Test Vectors for 800GBASE-ER1 FEC and PMA (Comment I-316)

Comment I-316 against D3.0

Proposed Text for Annex 186A

Figure 186A-1 Test vector points for 800GBASE-ER1 FEC

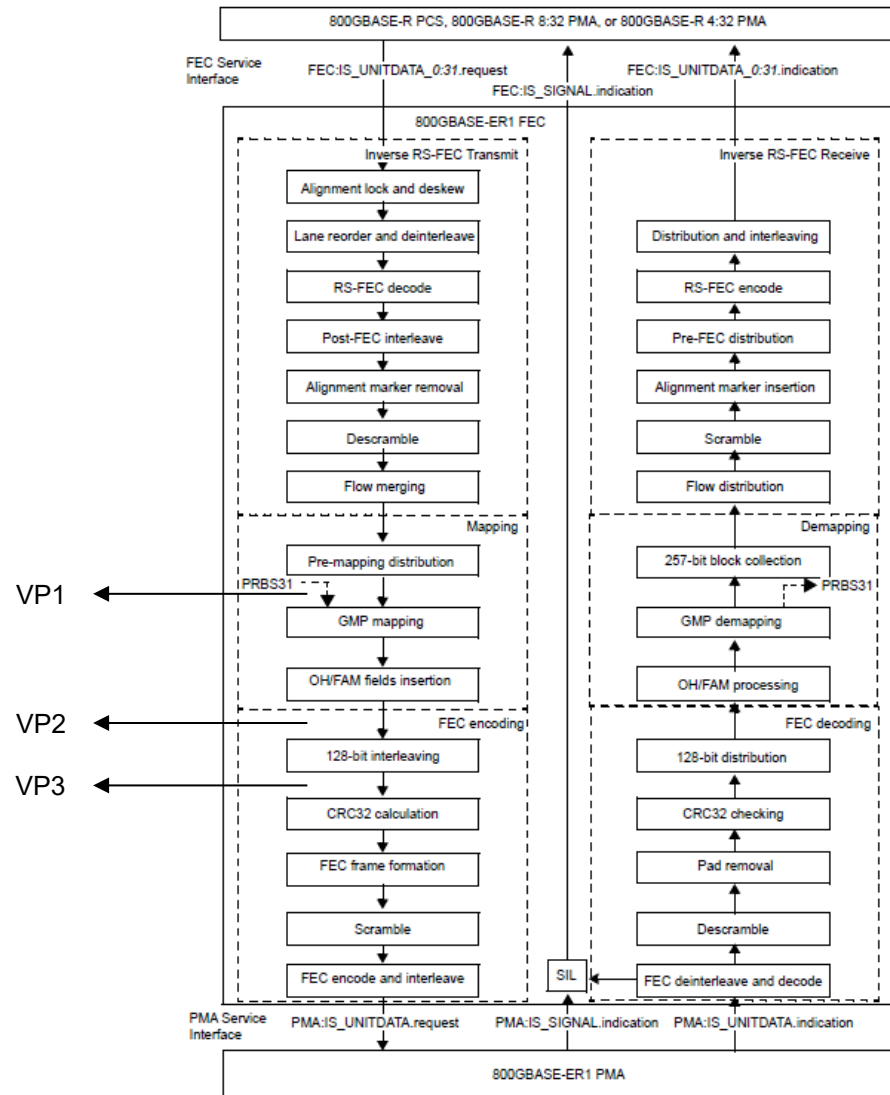
Test vectors are provided at test vector points VP1, VP2 and VP3 for the 800GBASE-ER1 FEC sublayer as shown Figure 186A–1. Test vectors are provided at test vector point VP4 for the 800GBASE-ER1 PMA sublayer as shown in Figure 186A–2.

The test vectors at VP1 are at the input to the GMP mapper function defined in 186.2.3.3.

The test vectors at VP2 are at the output of 800GBASE-ER1 tributary frame overhead insertion function defined in 186.2.3.5.

The test vectors at VP3 are at the output of the 128-bit interleaving function defined in 186.2.3.6.

Figure 186A-2 Test vector points for 800GBASE-ER1 PMA

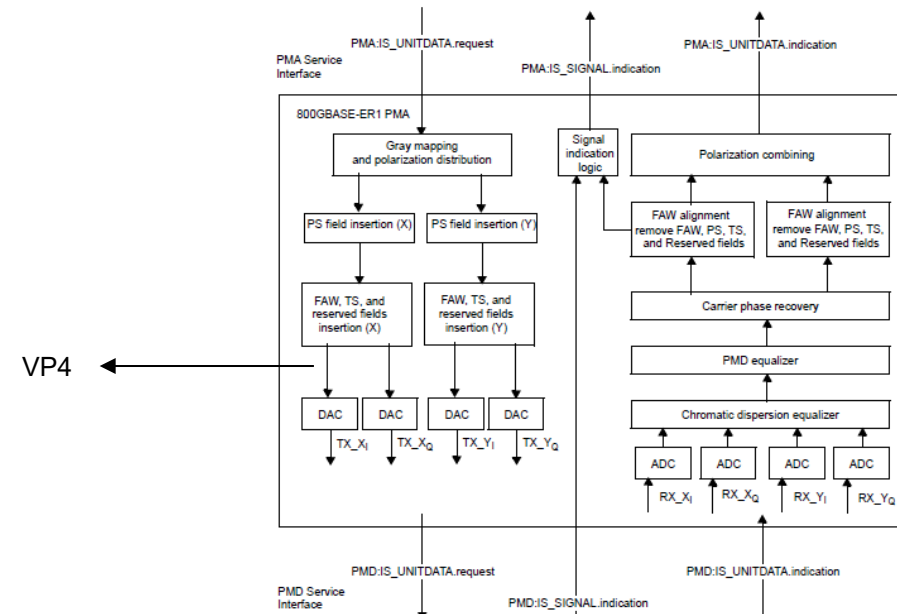
The test vectors at VP4 are at the output of the 800GBASE-ER1 PMA sublayer defined in 186.3.
